Mosqueda Community Center - Exterior  
4760 East Butler, Fresno

Mosqueda Community Center (MCC)

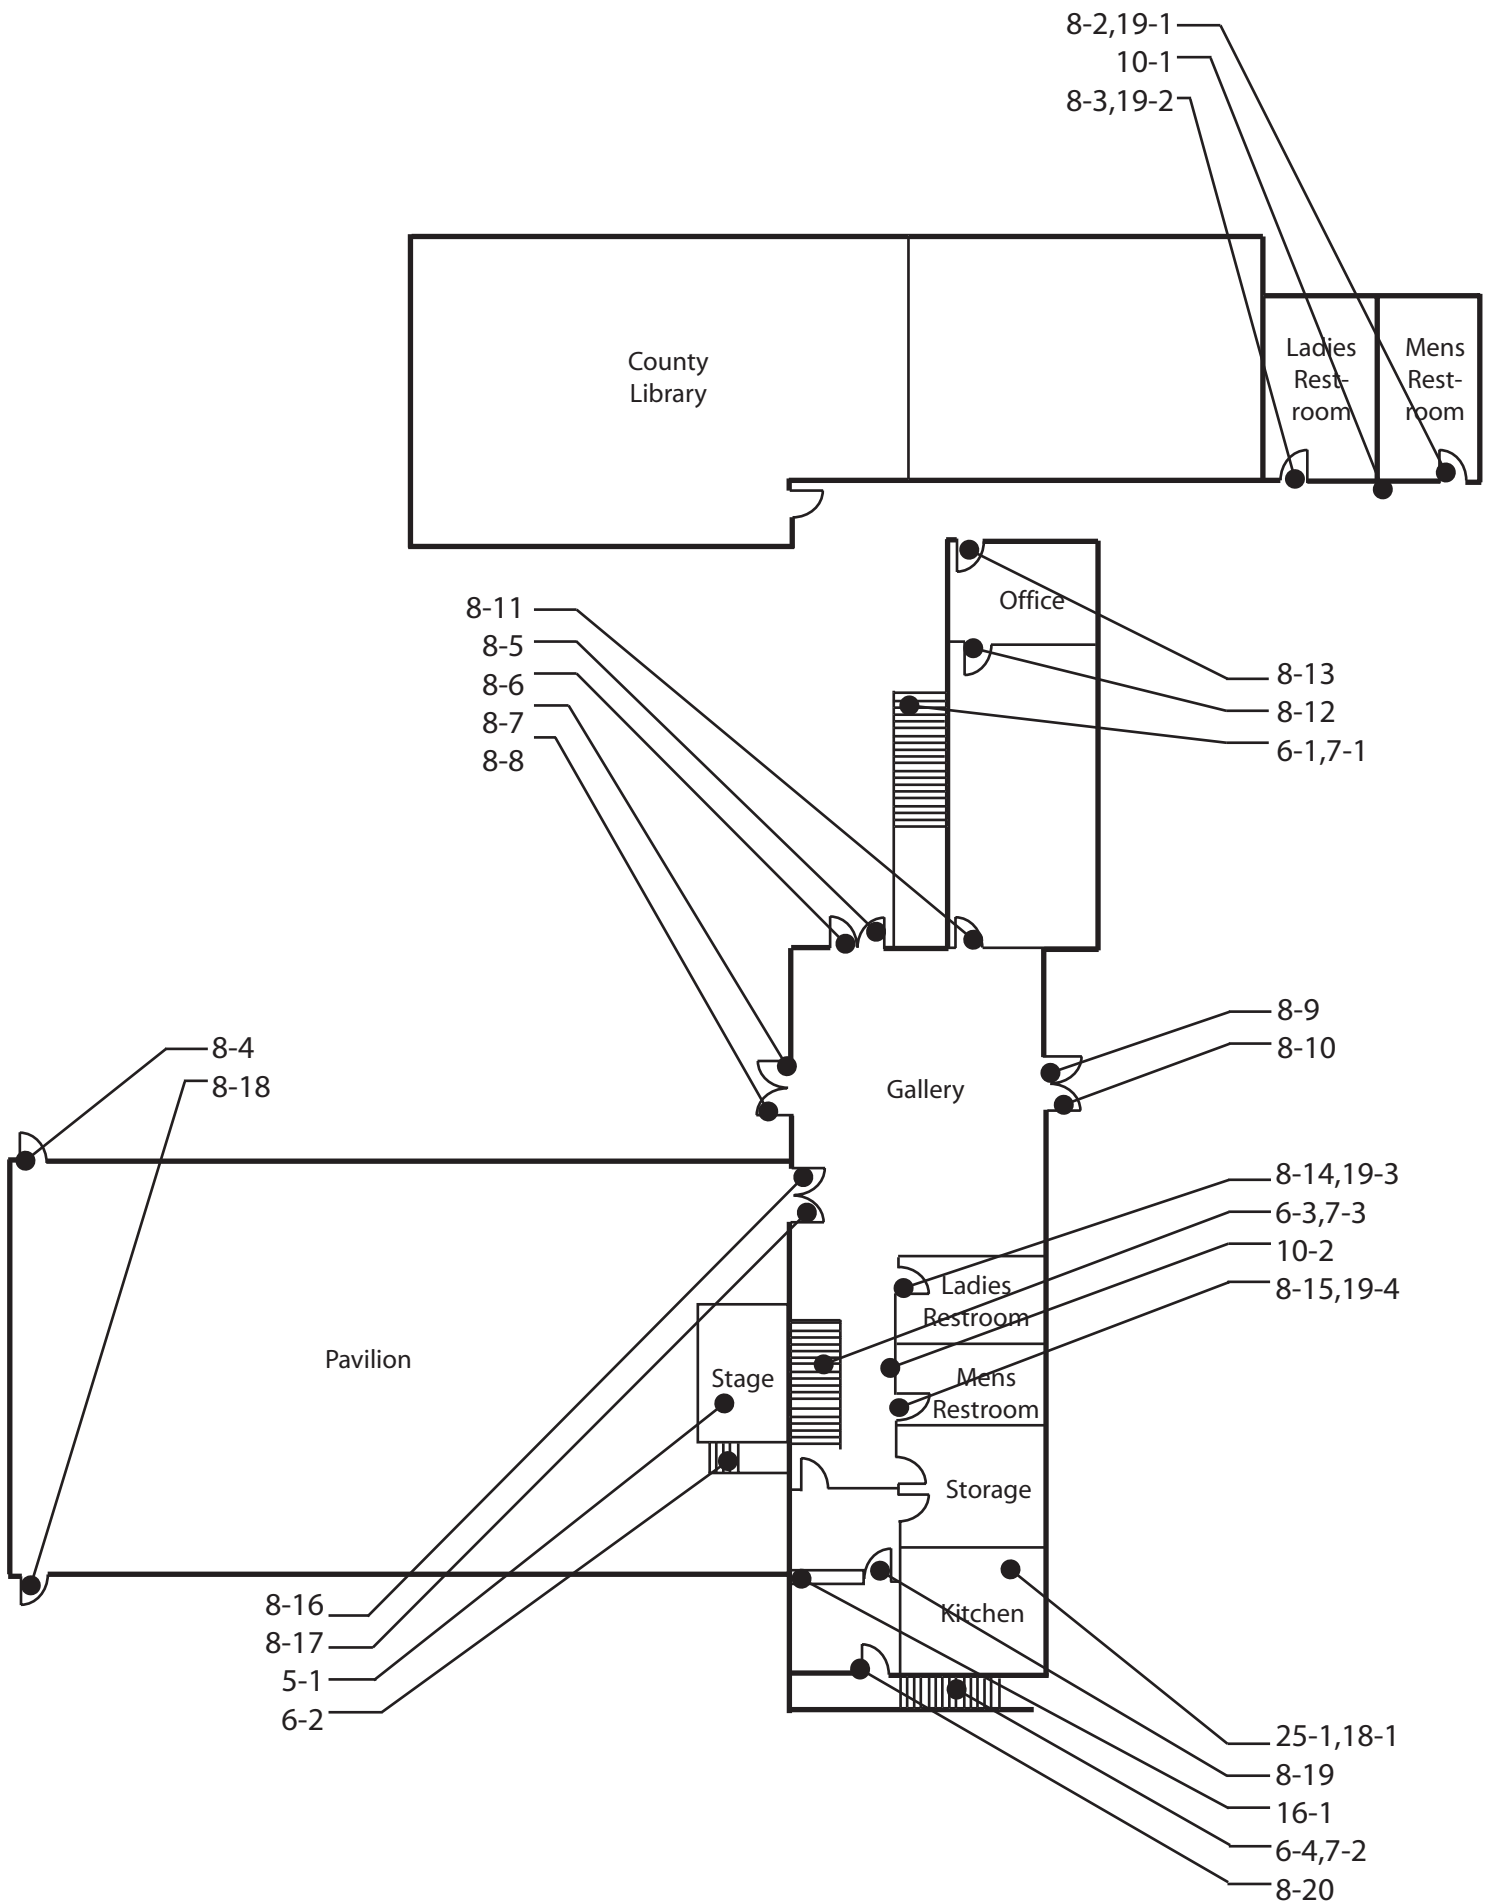
<b>Exterior</b>		
<b>1 - 1</b>	<b>Parking Area</b>	Priority: C
<b>Install sign</b>		\$100
Notes: There are two access aisles that do not have 'NO PARKING' painted in them.		
State: 1129B.3 #1, 1129B.3 #2		
Federal: -		
<b>Provide or modify accessible spaces</b>		\$50
Notes: The ISA is faded and needs to be repainted.		
State: 1129B.4		
Federal: 4.6.4		
<b>Install van parking sign</b>		\$250
Notes: The accessible parking sign says "Handicap Parking." It needs to be replaced with "Van Accessible".		
State: 1129B.4		
Federal: 4.6.4		
<b>Regrade surface</b>		\$3,600
Notes: Slope in the accessible parking stall is 2.4% (2% max). Slope in the access aisle is 4% (2% max).		
State: 1129B.3 #4		
Federal: 4.6.3		
<b>Provide or modify accessible access aisles</b>		\$150
Notes: Access aisle on the passenger side is 72" (96" min).		
State: 1129B.3 #2		
Federal: 4.6.3		
<b>3 - 1</b>	<b>Curb Ramp</b>	Priority: C
<b>Install, replace or modify curb ramp</b>		\$2,500

Notes: Slope of curb ramp is 8.6% (8.33% max). Slopes of flared sides are 12.6% and 16.4% (10% max).		
State: 1127B.5 #3		
Federal: 4.7.5, 4.8.2		
<b>Provide surface texturing</b>		\$0
Notes: Surface material does not contrast with surrounding sidewalks.		
State: 1127B.5 #5		
Federal: -		
<b>4 - 1</b>	<b>Walk</b>	Priority: C
<b>Regrade surface</b>		\$1,800
Notes: Cross slope is 3.7% (2% max).		
State: 1133B.7.1.3		
Federal: 4.3.7

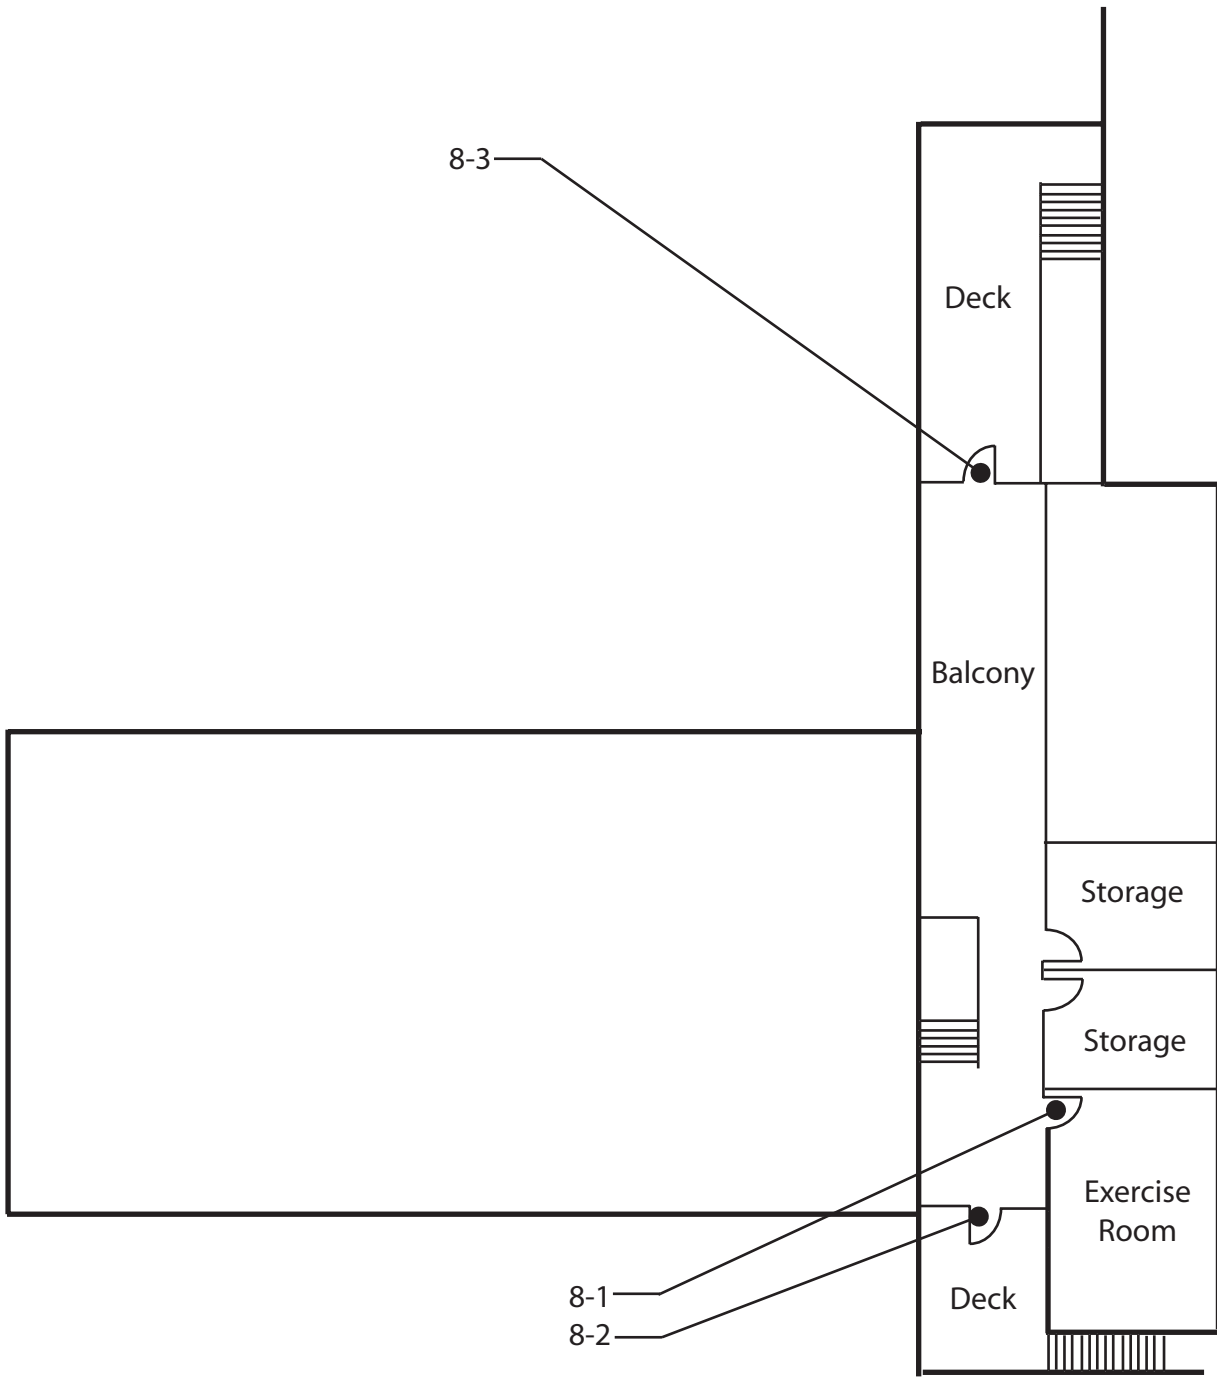
<b>Floor 1</b>	
<b>19 - 4 Multiple User Restroom</b>	<b>Priority:2</b>
<b>Modify stall partitions and doors</b>	<b>\$500</b>
Notes: Stall width is 36" (60" min).	
State: -	
Federal: 4.17.3	
<b>Reposition toilet flush controls</b>	<b>\$750</b>
Notes: Flush control is not located on the wide side.	
State: 1115B.4.1 #5	
Federal: 4.16.5	
<b>Replace or reposition dispensers or mirrors</b>	<b>\$200</b>
Notes: Mirror is mounted so bottom of reflecting surface is 48-1/2" (40" max) AFF.	
State: 1115B.8.1	
Federal: 4.19.6	
<b>Replace or reposition dispensers or mirrors</b>	<b>\$750</b>
Notes: Towel dispenser is 62" (40" max), soap dispenser is 41" (40" max), and waste container is 45-1/2" (40" max) AFF.	
State: 1115B.8.3	
Federal: 4.23.7	
<b>Insulate water lines</b>	<b>\$100</b>
Notes: Hot water pipe is not insulated.	
State: 1115B.4.3 #4	
Federal: 4.19.4	
<b>Replace or reposition urinal</b>	<b>\$3,500</b>
Notes: Urinal is 24" (17" max) AFF. Flush control is 44-1/2" (44" max) AFF.

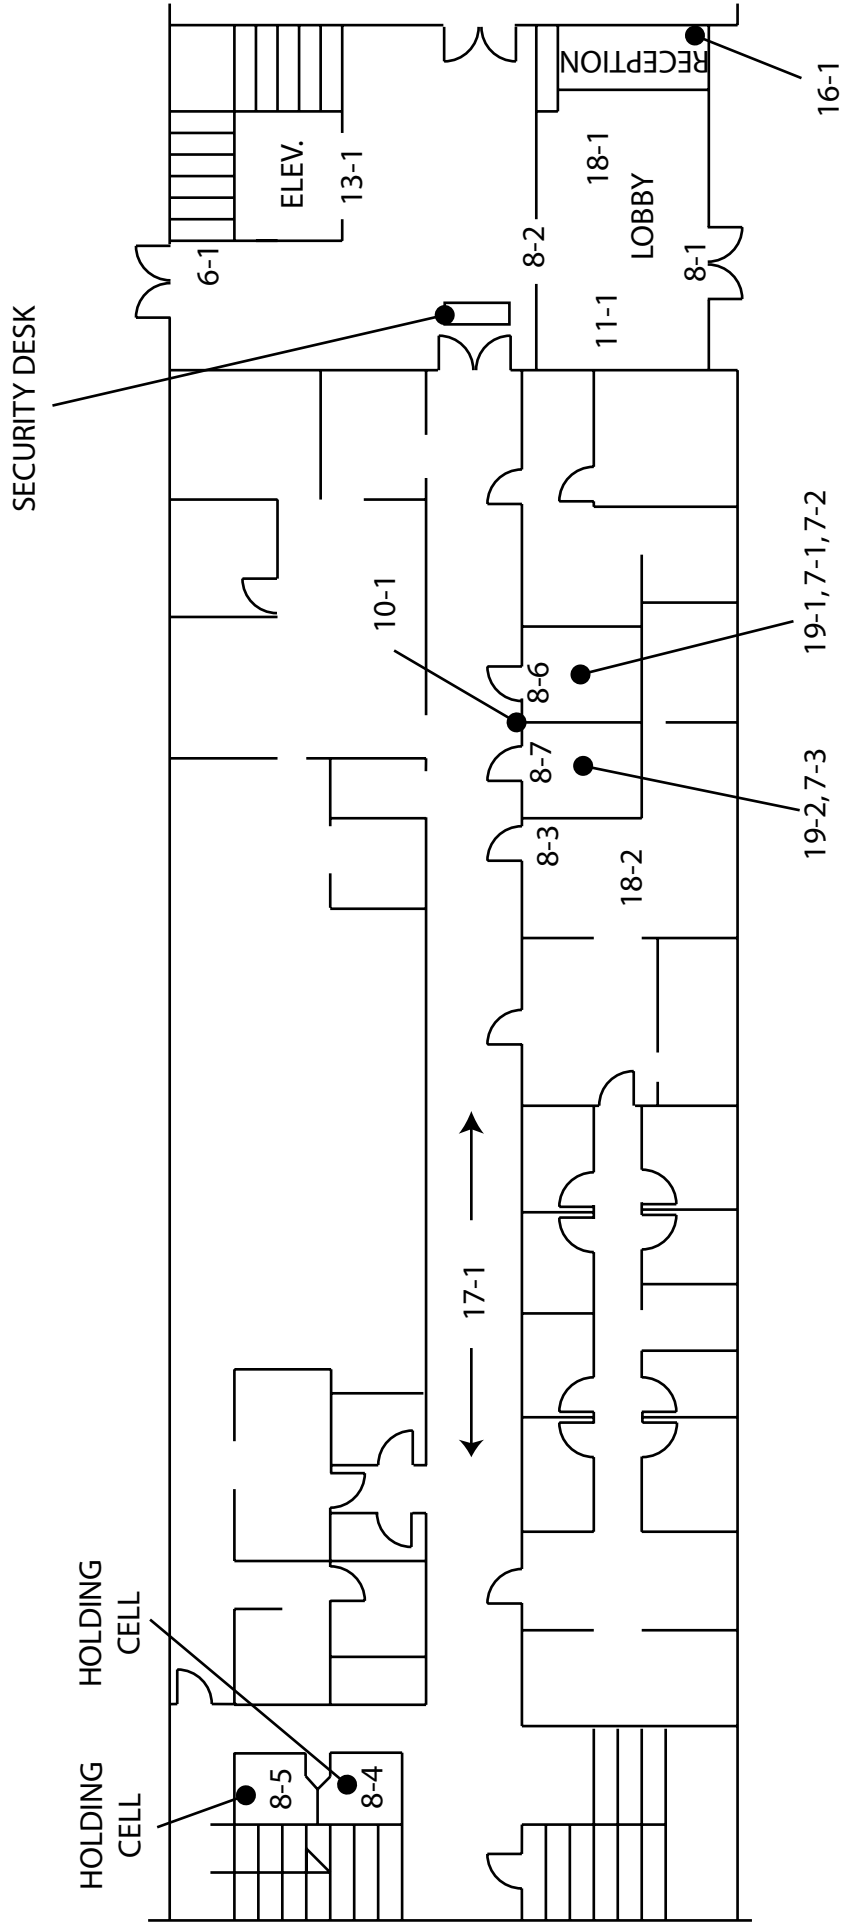
<b>Floor 2</b>	
<b>8 - 1</b>	<b>Door/Gate</b> <span style="float: right;">Priority: 4</span>
<b>Replace or adjust door hardware</b> <span style="float: right;">\$300</span>	
Notes: Doorknob requires grasping and twisting. Second floor not in use.	
State: 1133B.2.5.2	
Federal: 4.13.9	
<b>8 - 2</b>	<b>Door/Gate</b> <span style="float: right;">Priority: 4</span>
<b>Provide or modify door kickplate</b> <span style="float: right;">\$100</span>	
Notes: Kickplate is 4" (10" min) high. Second floor not in use.	
State: 1133B.2.6	
Federal: -	
<b>8 - 3</b>	<b>Door/Gate</b> <span style="float: right;">Priority: 4</span>
<b>Provide or modify door kickplate</b> <span style="float: right;">\$100</span>	
Notes: Kickplate is 4" (10" min) high. Second floor not in use.	
State: 1133B.2.6	
Federal: -	
<b>Install or modify permanent room signs</b> <span style="float: right;">\$250</span>	
Notes: There is an exit sign but Braille is not provided.

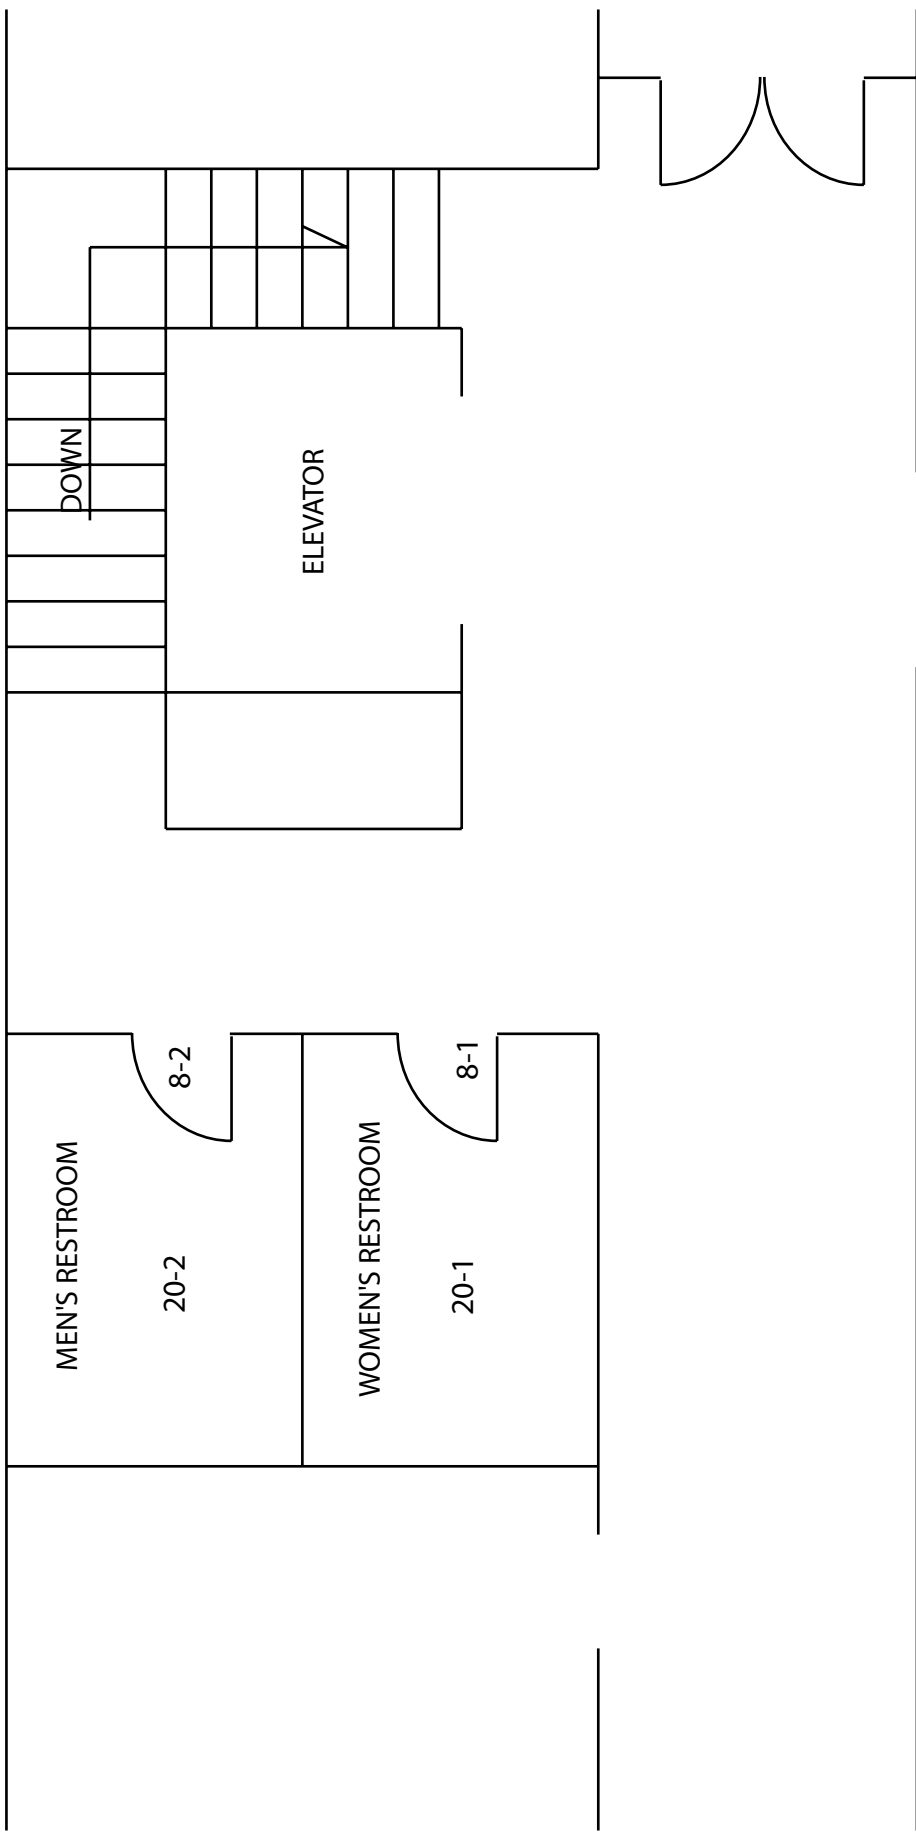
<b>Floor 1</b>	
<b>19 - 2 Multiple User Restroom</b>	Priority: 4
<b>Replace or reposition dispensers or mirrors</b>	\$200
Notes: Mirror is mounted so bottom of reflecting surface is 50-1/2" (40" max) above the finished floor.	
State: 1115B.8.1	
Federal: 4.19.6	
<b>Install sign</b>	\$250
Notes: California required signage is not provided on the door. International Symbol of Accessibility is not provided.	
State: 1115B.6, 1117B.5.1 #1, 1117B.5.5 #3, 1117B.5.8.1.2	
Federal: 4.30.4	
<b>Install sign</b>	\$250
Notes: Federal required signage is not provided on the latch side of the door.	
State: 1115B.6, 1117B.5.1 #1	
Federal: 4.30.4	
<b>Replace or reposition dispensers or mirrors</b>	\$250
Notes: Towel dispenser is 61" (40" max) above the finished floor.	
State: 1115B.8.3	
Federal: 4.23.7	
<b>Replace or adjust water controls</b>	\$500
Notes: Faucet control requires grasping and twisting.	
State: 1115B.8.3	
Federal: 4.19.5, 4.27.4

<b>Insulate water lines</b>	\$100
Notes: Hot water and drain pipes are not insulated.	
State: 1115B.4.3 #4	
Federal: 4.19.4	
<b>Modify stall partitions and doors</b>	\$800
Notes: Stall door is 30" (32" min) for end-entry stall.	
State: 1115B.3.1 #4.4	
Federal: -	
<b>Provide or replace stall door hardware</b>	\$200
Notes: U-shaped handles are not provided on the front or back of stall door. Stall door is not self-closing.	
State: 1115B.3.1 #4.5	
Federal: 4.13.9

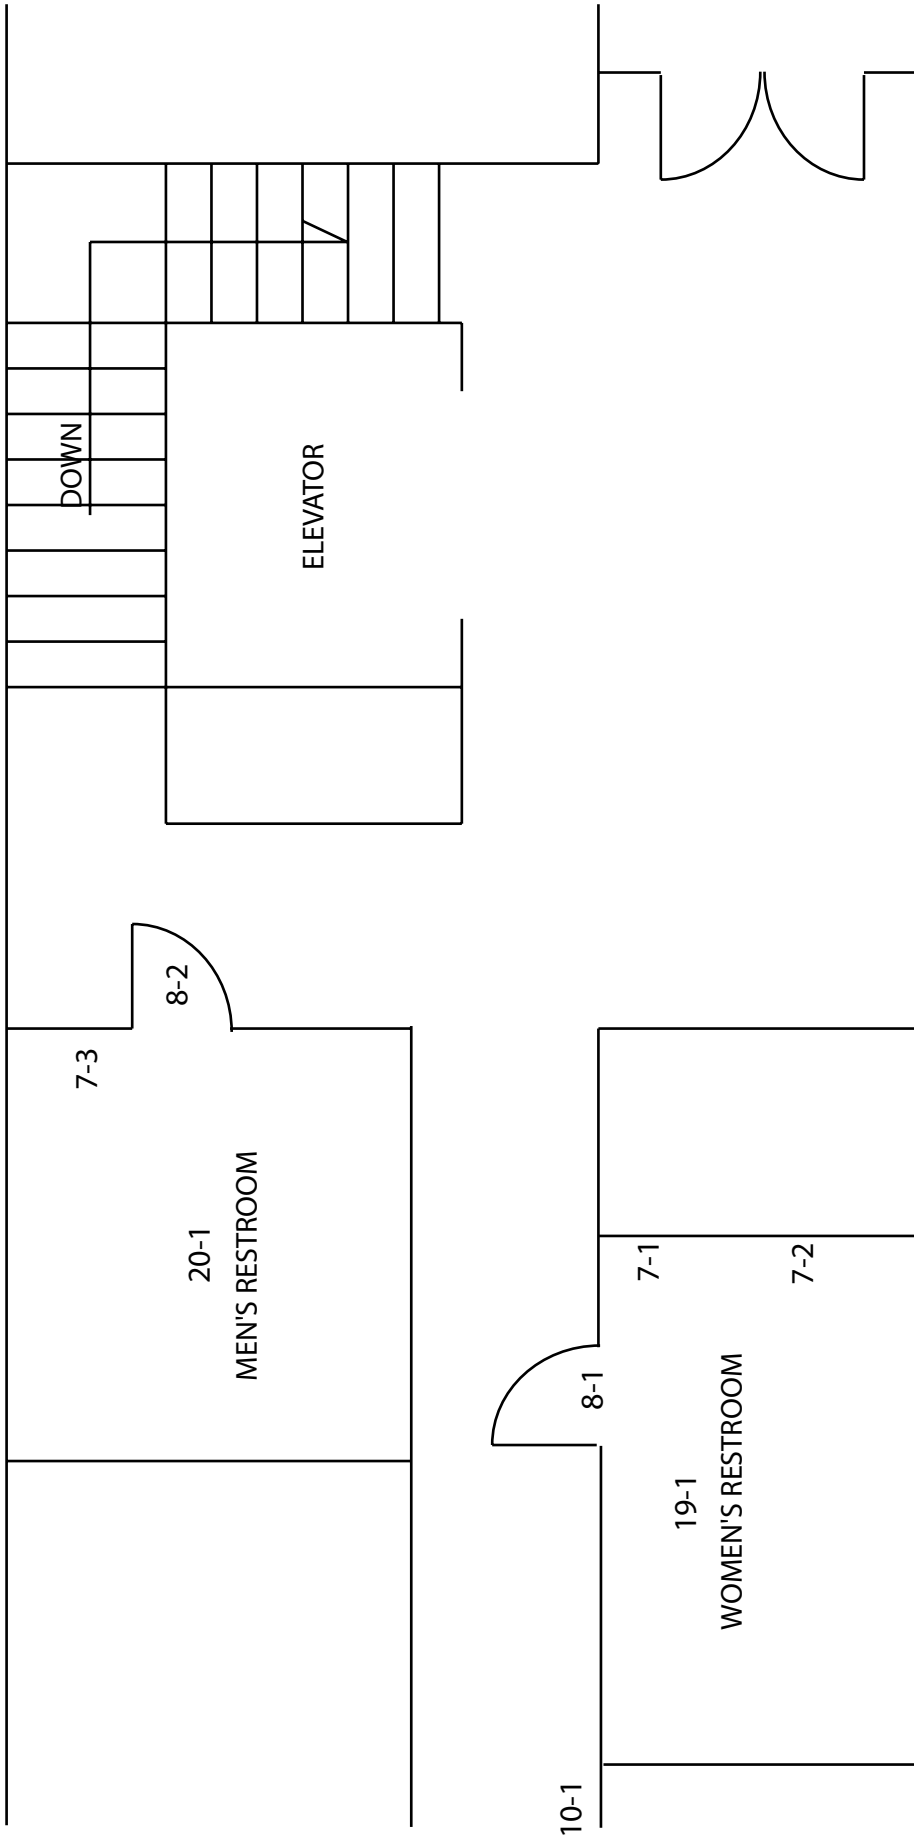
<b>Floor 2</b>	
<b>20 - 2 Single User Restroom</b>	<b>Priority: 4</b>
<b>Install sign</b>	<b>\$250</b>
Notes: California required signage is centered 66" (60" req) above the finished floor.	
State: 1115B.6	
Federal: 4.30.4	
<b>Install sign</b>	<b>\$250</b>
Notes: Change to Staff only restroom. Federal required signage is not provided on the latch side of the door.	
State: 1115B.6, 1117B.5.1 #1	
Federal: 4.30.4	
<b>Replace or reposition dispensers or mirrors</b>	<b>\$250</b>
Notes: Mirror is mounted so bottom of reflecting surface is 40-1/2" (40" max) above the finished floor.	
State: 1115B.8.1	
Federal: 4.19.6	
<b>Replace or reposition dispensers or mirrors</b>	<b>\$300</b>
Notes: Towel dispenser is 53-1/2" (40" max) and soap dispenser is 41" (40" max max) above the finished floor.	
State: 1115B.8.3	
Federal: 4.23.7	
<b>Modify lavatory/counter clearances</b>	<b>\$3,500</b>
Notes: Height of the counter is 35-1/2" (34" max) above the finished floor.
